SUBJECT: REQUESTS SCHEDULE CHANGE IN TWO-UNIT THERMAL PLUME MAPPINGS  
 TO JUNE 1979.ALSO INFORMS NRC OF PROPOSED MOD TO DISCHARGE  
 STRUCTURE SCOUR BED TO ALLEVIATE EROSION PROBLEMS.TWO  
 OVERSIZED STRUCIURAL DRAWINGS ENCL.

Donald C. Cook Nuclear Plant Units 1 and 2  
Docket Nos. 50-315 and 50-316  
License Nos. DPR-58 and DPR-74  
Appendix B Technical Specifications

UNIT NO.1 DISCHARGE STRUCTURE  
SITE DEVELOPMENT PLAN & SECTIONS  
DONALD C. COOK NUCLEAR PLANT  
INDIANA & MICHIGAN ELECTRIC CO.  
BRIDGMAN, MICHIGAN

12-3722

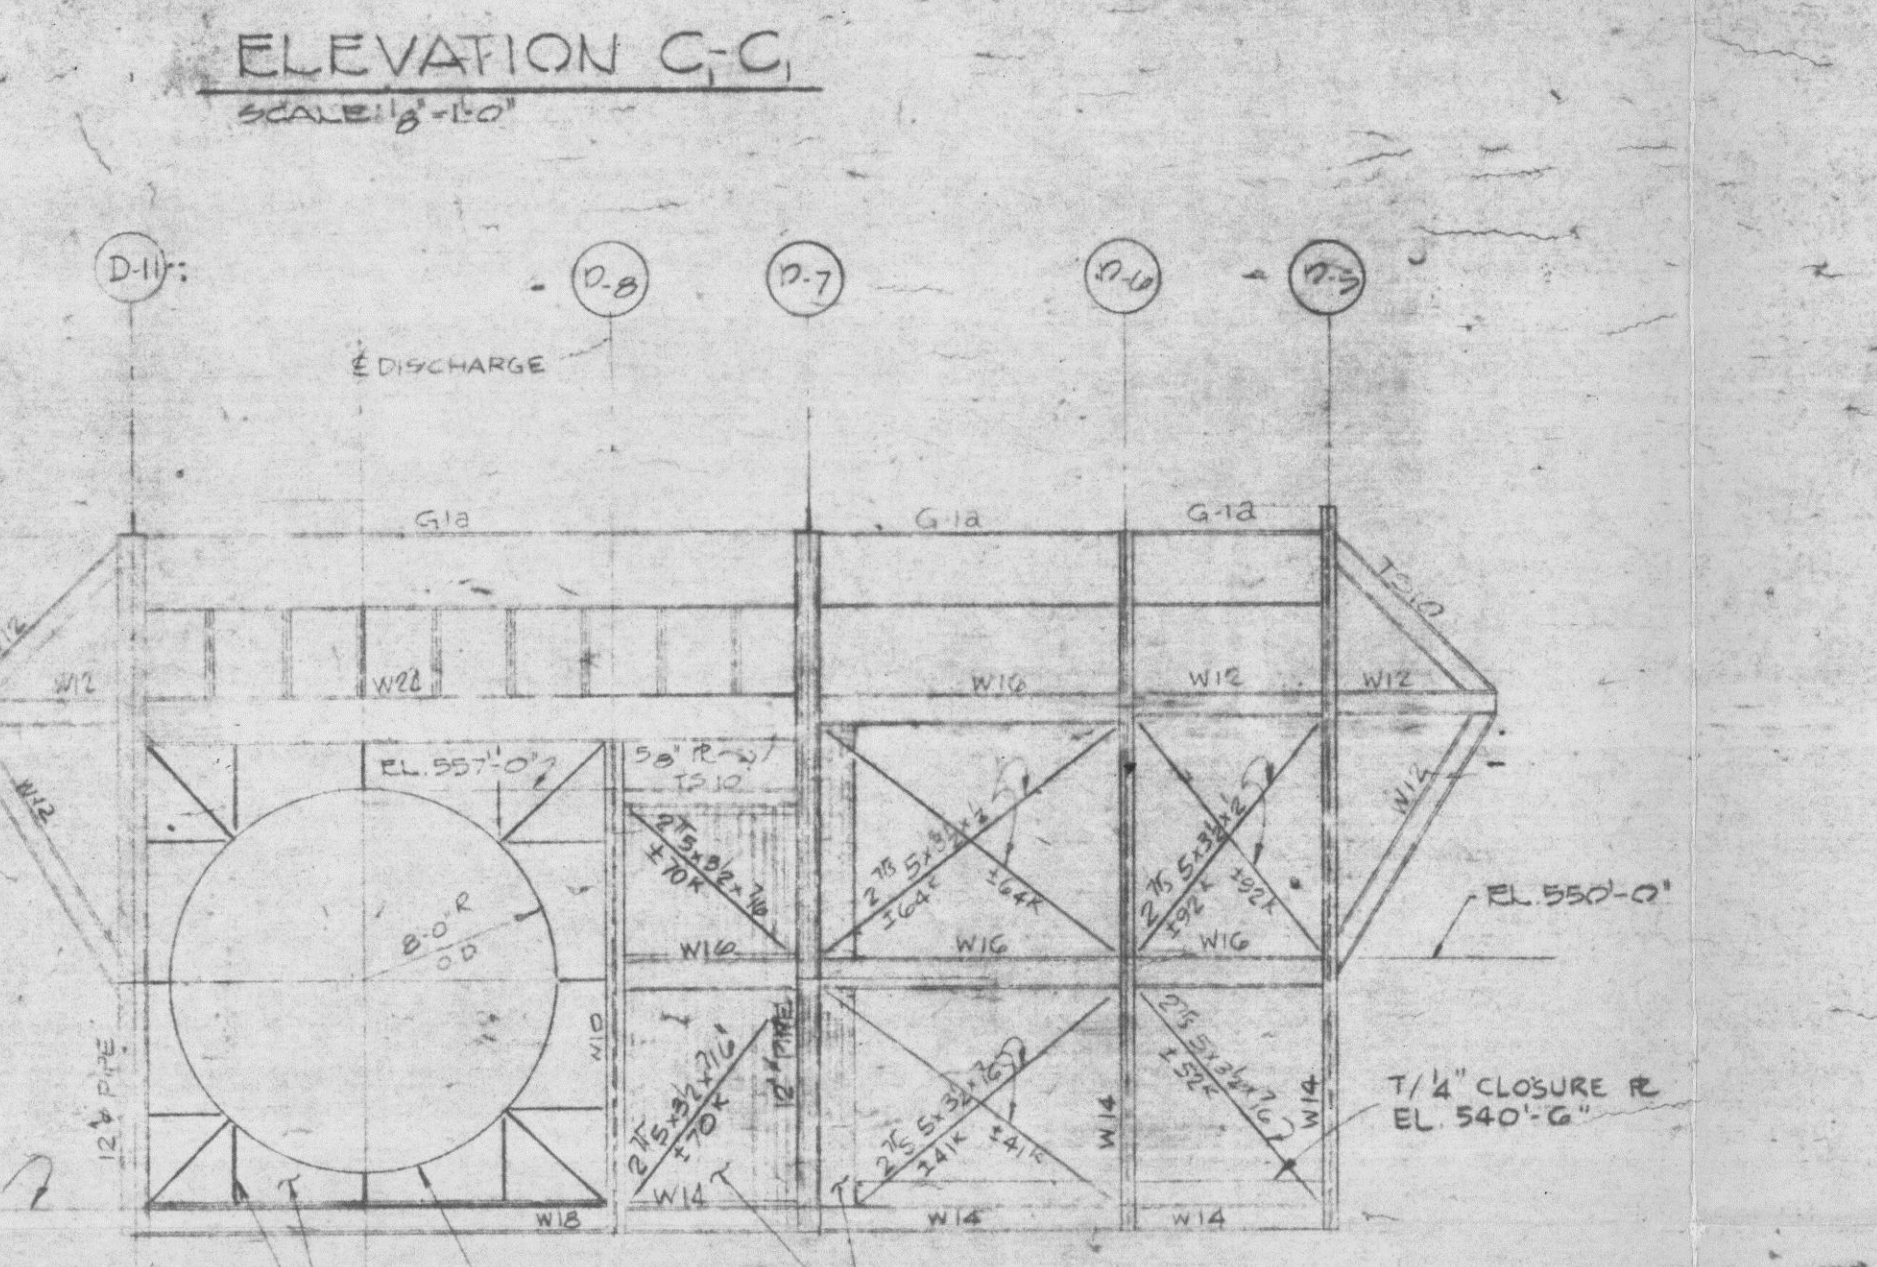
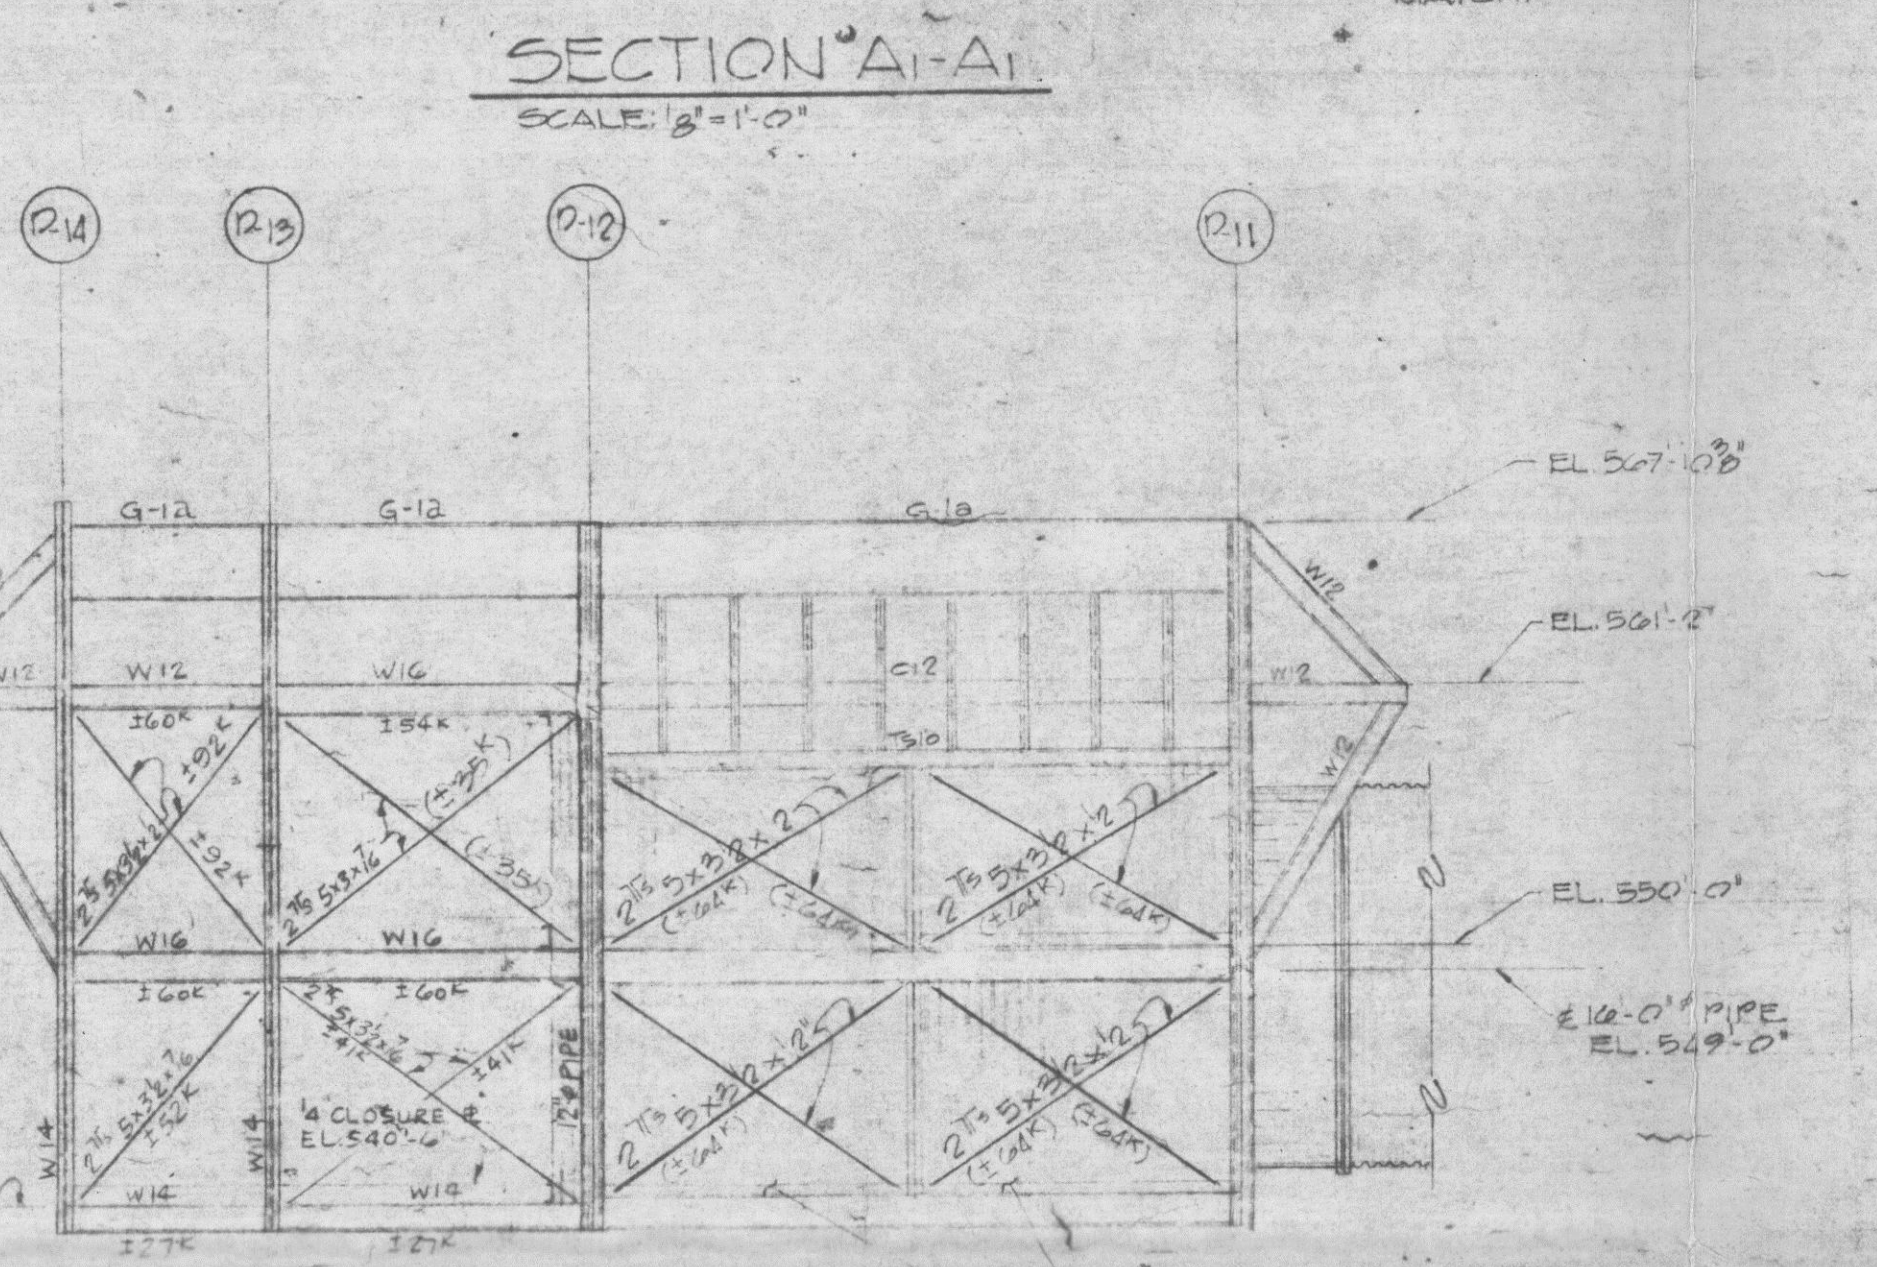
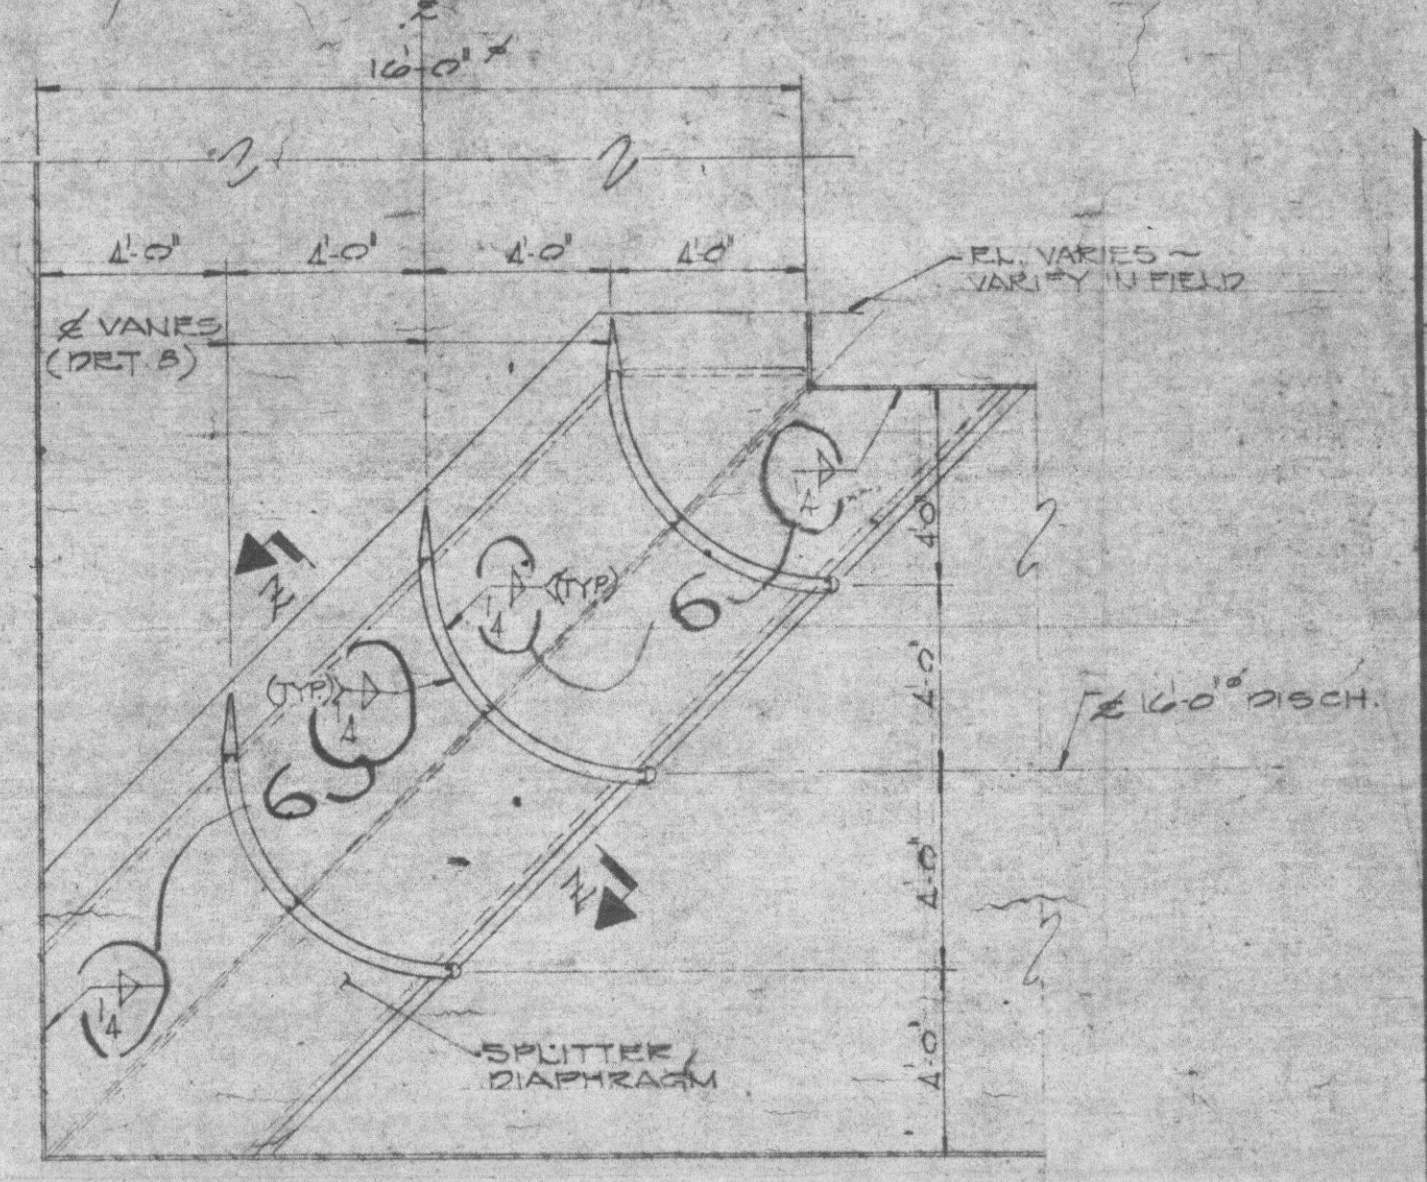
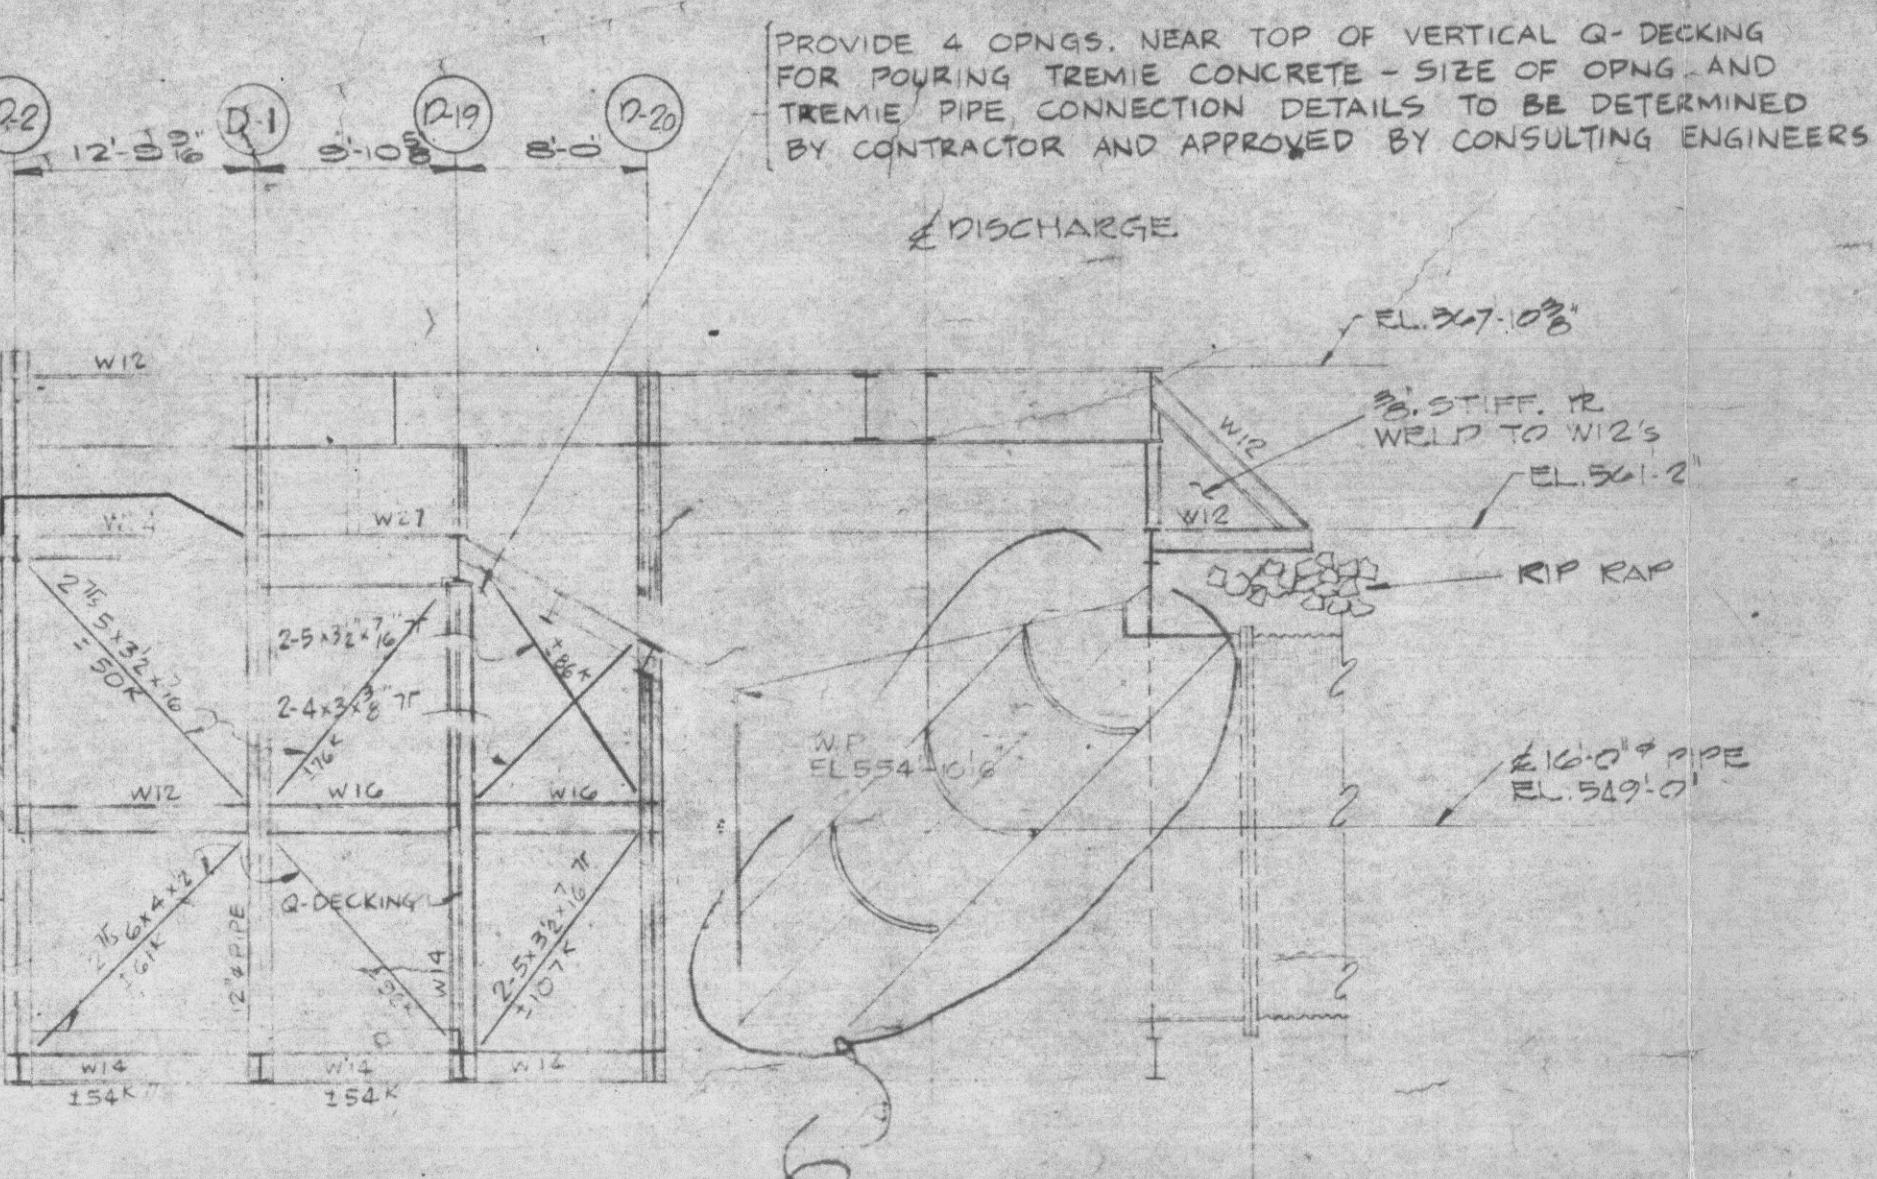
As a temporary measure, the existing riprap was regraded and levelled to its original design elevation. Nevertheless, the erosion problems continued. A permanent solution was sought and a concrete scour bed was chosen. The plan and section of the proposed scour bed are shown on Drawing No. 12-3722, also attached.

The following procedure will be used to place the concrete scour bed. First, the existing riprap will be graded to approximate elevation of 558 feet. This will halt the undermining problem. The second step is to create a mattress with 1½"-5" stones placed to an elevation of 559'-2". This mattress stone is much easier to level than the original riprap due to the smaller dimensions of the stones used. This solid scour bed would prevent entrainment of water under the structure. The next step would be to pour 2 feet of concrete over the mattress stone. Concrete will also be placed within the confines of the iceguards which extend 6 feet out from the structure. This area includes the sections in front of the nozzles as well as the sections on the sides for a total length of 129'-2-5/8". Any unused riprap will be used to alleviate any discontinuities of elevation between the concrete scour bed and the original riprapped scour bed elevation.
